| 6/16/82 | Added General Note III i. |

STATE OF HAWAII  
DEPARTMENT OF TRANSPORTATION  
LAND TRANSPORTATION FACILITIES DIVISION  
**INSTALLATION OF  
UNIVERSAL TESTING MACHINE**  
Project No. HWY-0-03-81

Scale: As Noted  
Date: May, 1982  
SHEET NO. 1 OF 3 SHEETS

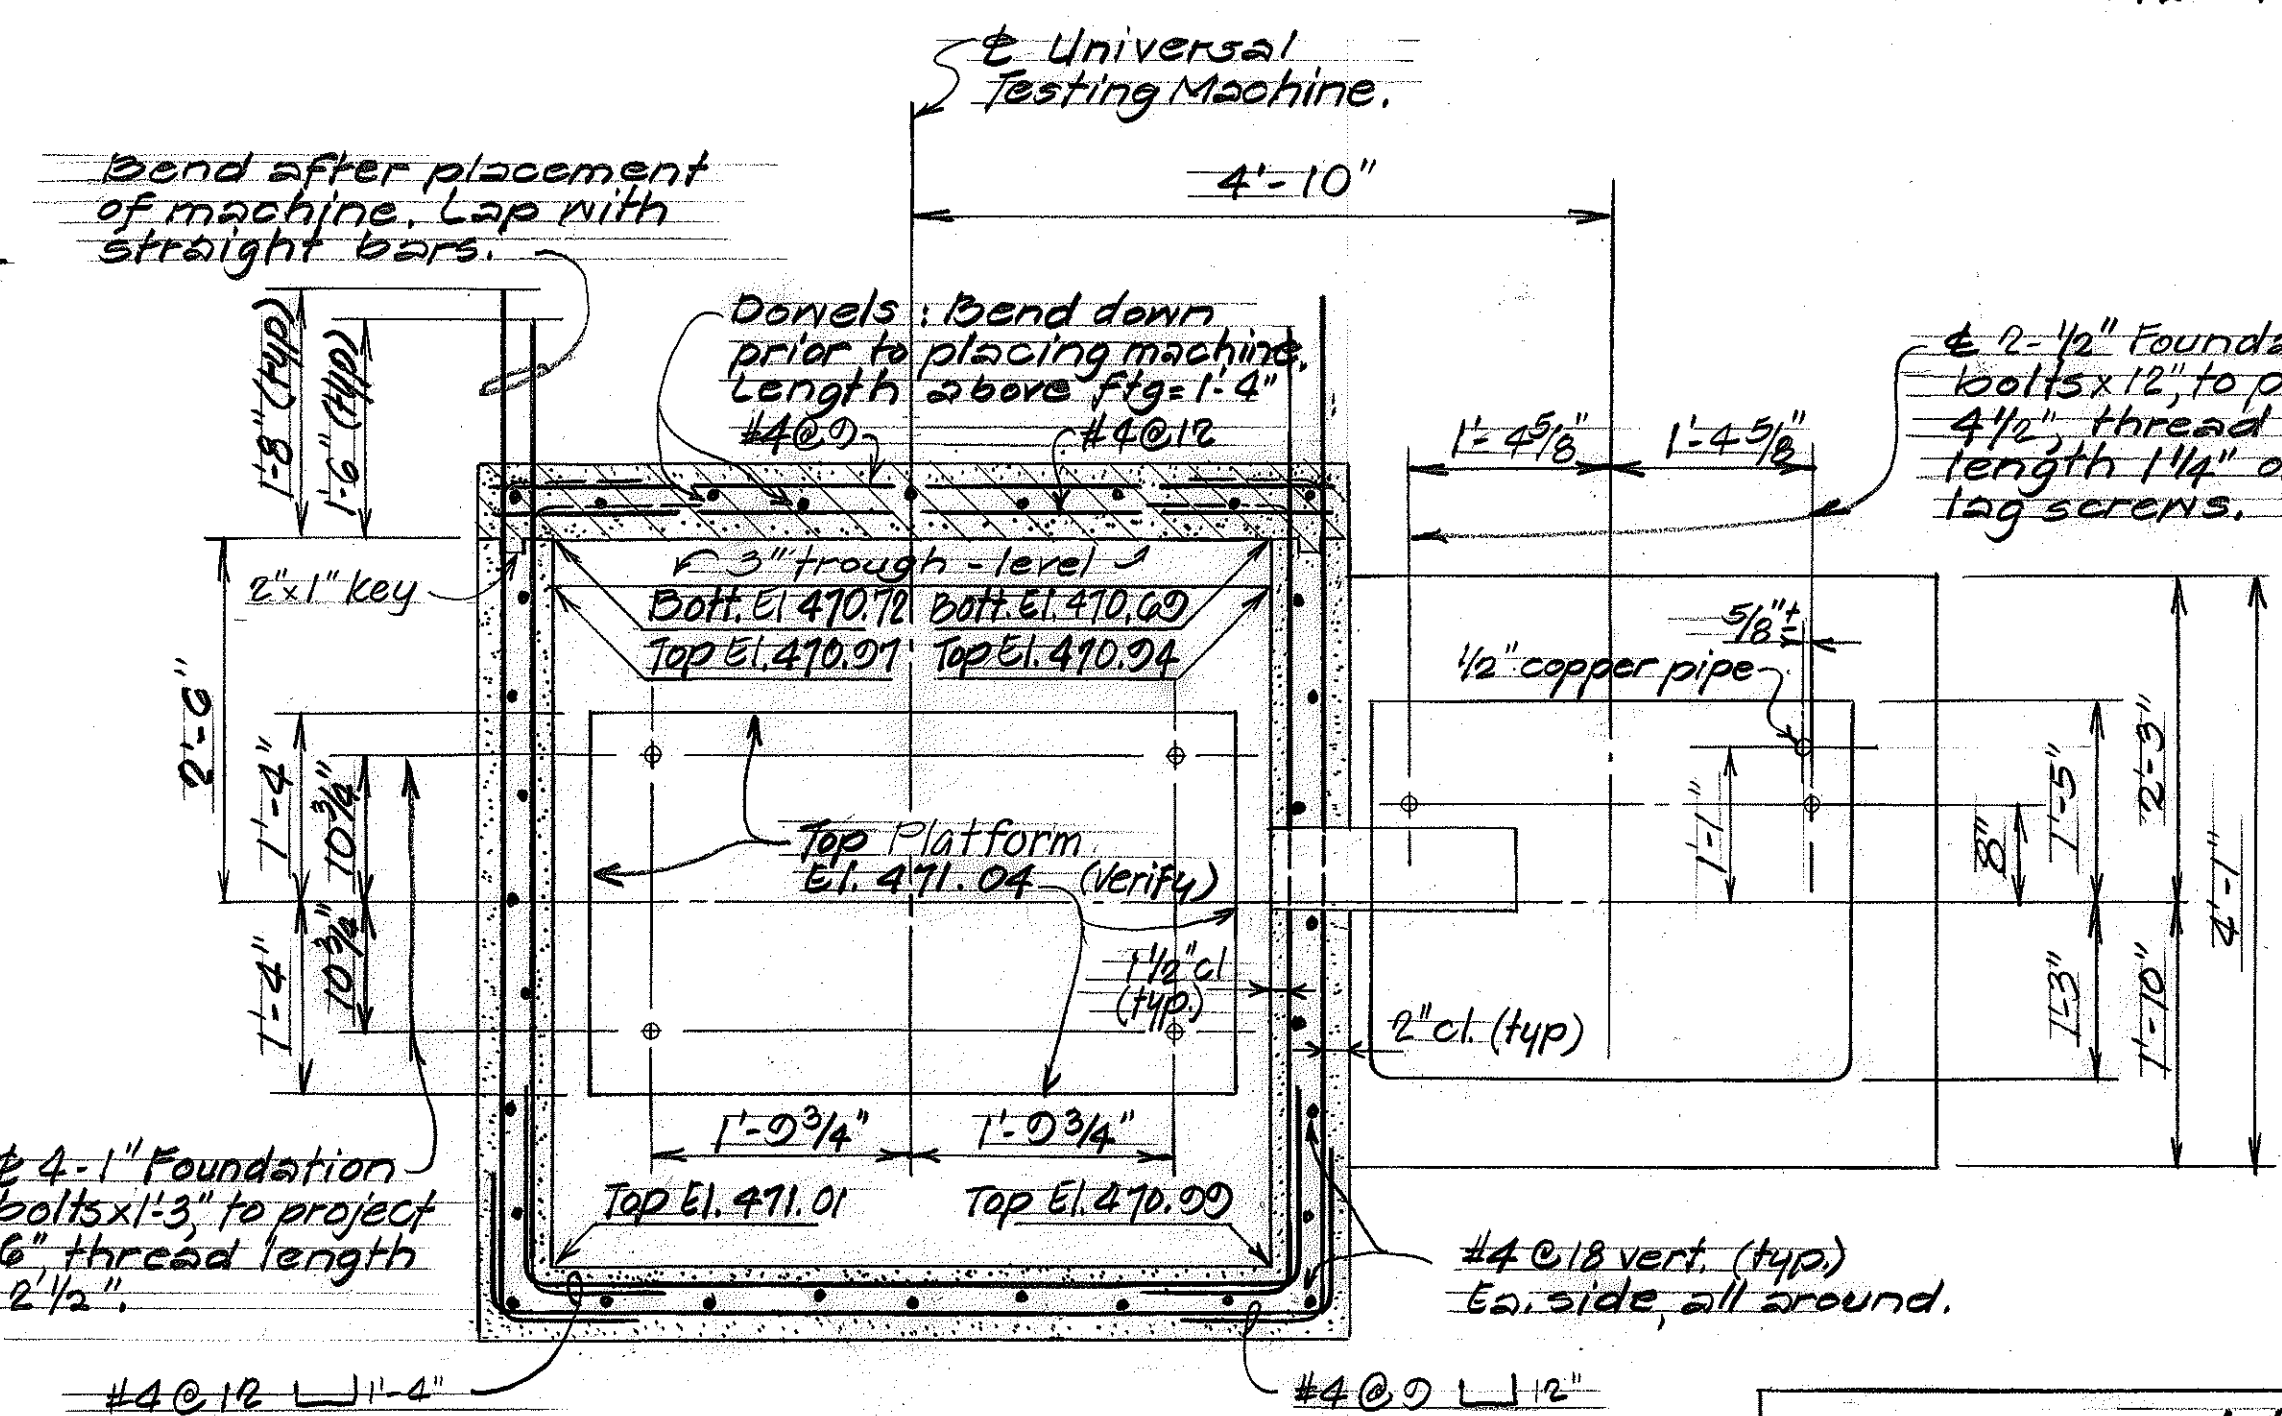
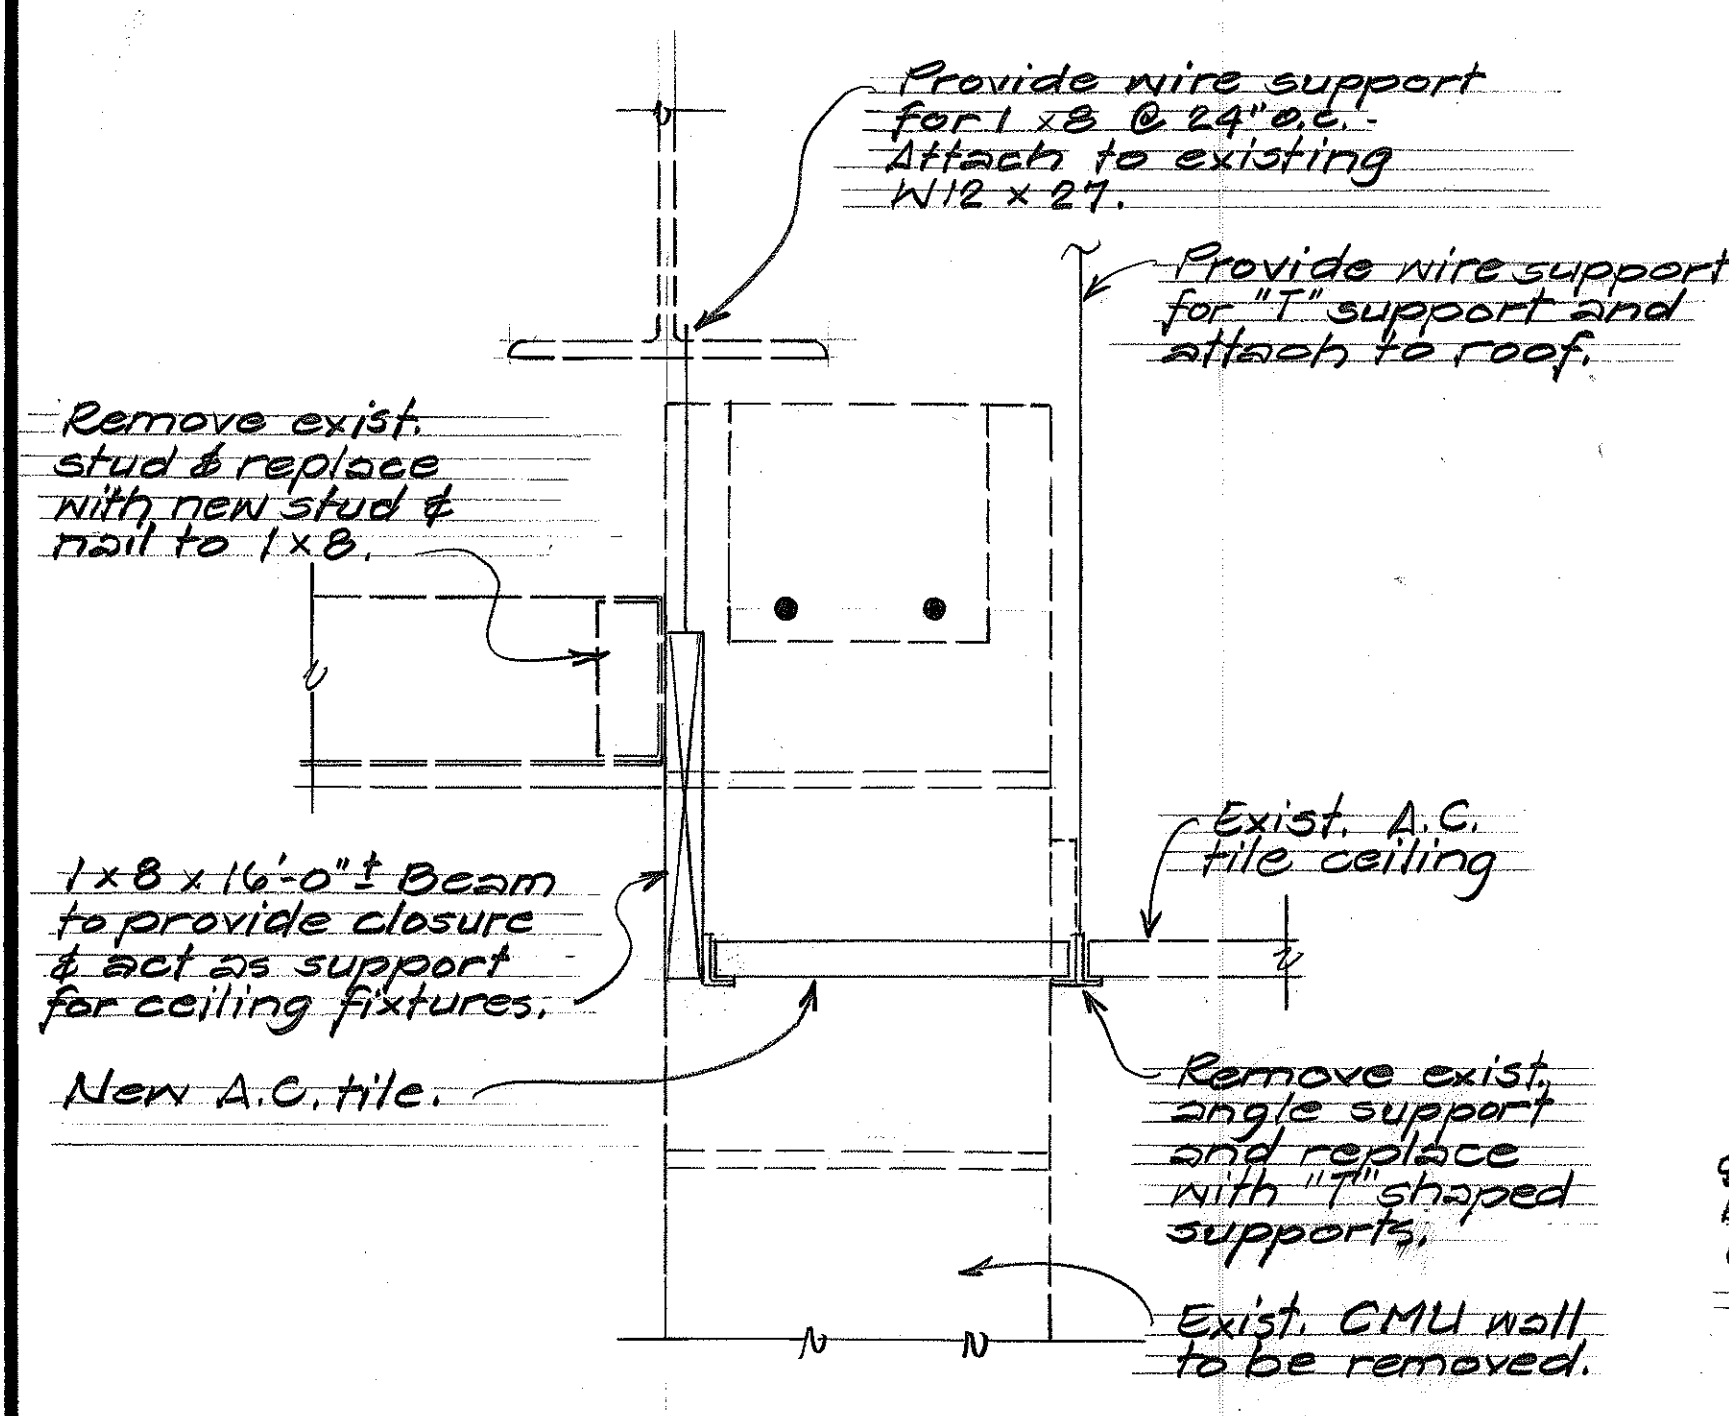
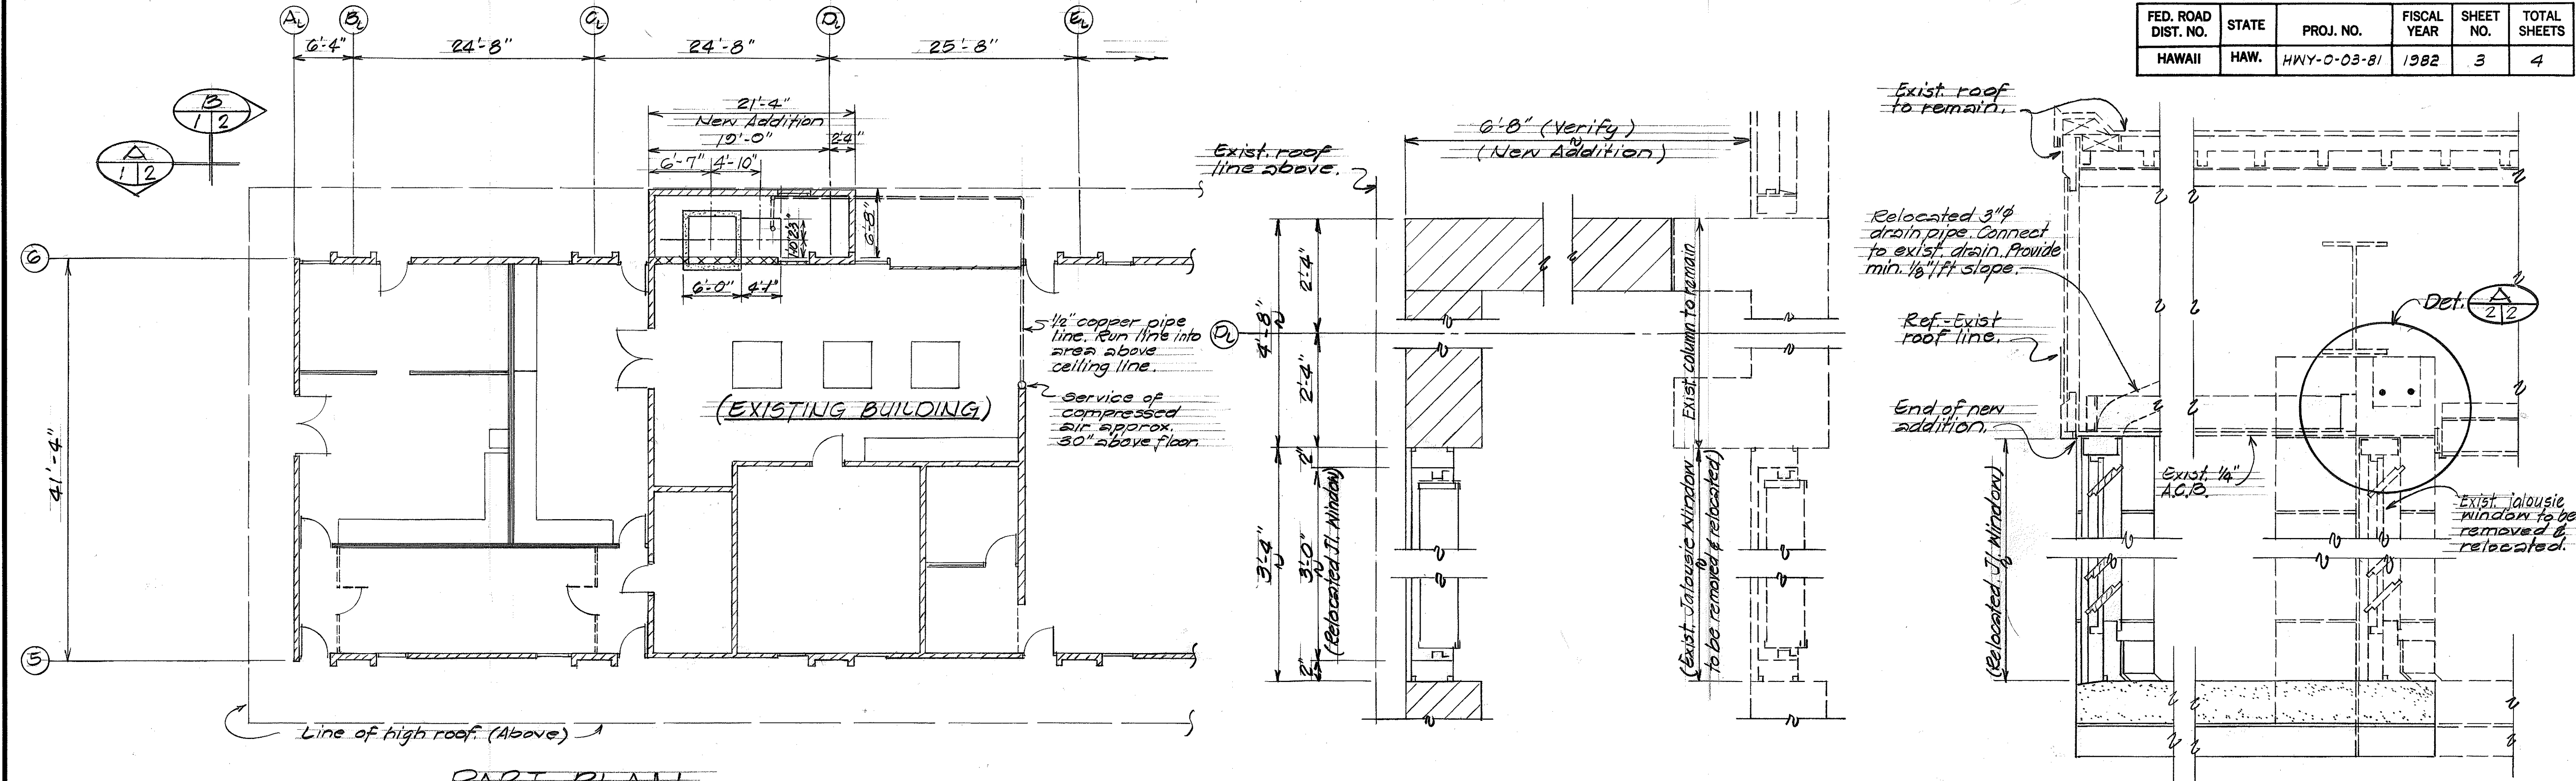
| 6/16/82                                                                                                                                                                             | PART PLAN and SECTION A-2/3 revised to show pipes for compressed air. SECTION A-2/3 dimensions revised from 1'-9 3/4" to 1'-4 5/8". |
